Planning Application Number: 25/00537/REM

Application Address: Land North Of A47 Normandy Way And East Of Stoke Road Hinckley

Description of Application: Approval of reserved matters (appearance, landscaping, layout and scale) of outline planning permission 22/00318/OUT for construction of 475 dwellings and associated infrastructure and landscaping works.

## **Substantive Response provided in accordance with article 22(5) of The Town and Country Planning (Development Management Procedure) (England) Order 2015:**

## **Proposed school**

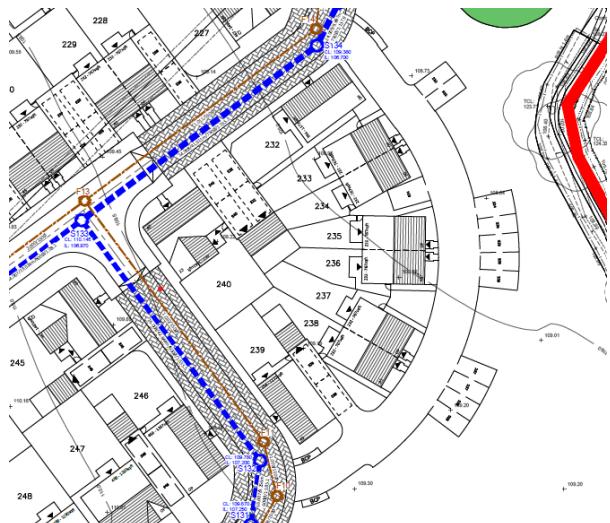
Please detail the school access points are to be installed on the design plan.

Please note the width of the spine road serving the schools should comply with our highway design guide, further information can be found using the link below.

## **Unadoptable road design**

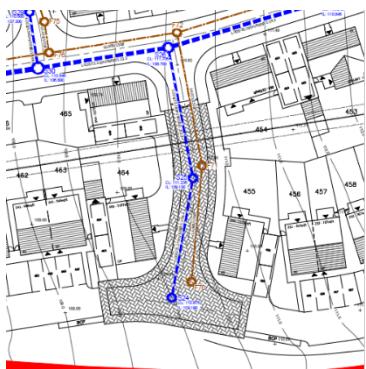
The design plan details that the roads shown below, fail to serve the required number of direct frontage access points (minimum of 6 or more) as detailed in (LHDG) ref the link below design principles.

Please note even if the road provides access to private drives this not counted as direct frontage access.

## **Junction visibility**

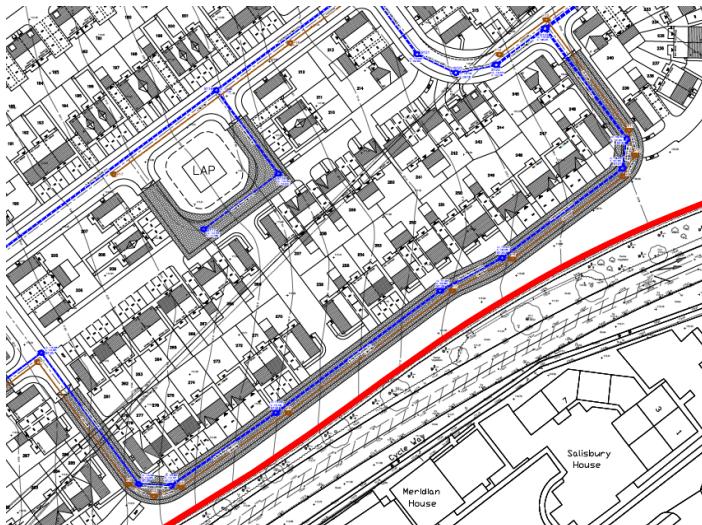
Please detail 25m visibility splays will be provided at all junctions within the development on the design plan. Please note these must be contained within the highway boundary, please reference link below.

## **Turning head radii**

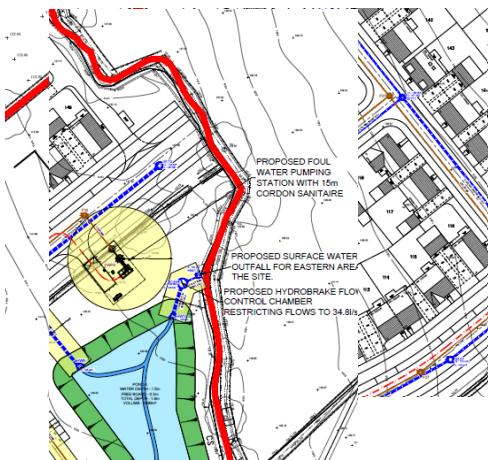
Please detail the turning head radii on the design plan, further information relating to the LHA's design standards which can be found in (LHDG), please reference the link below.
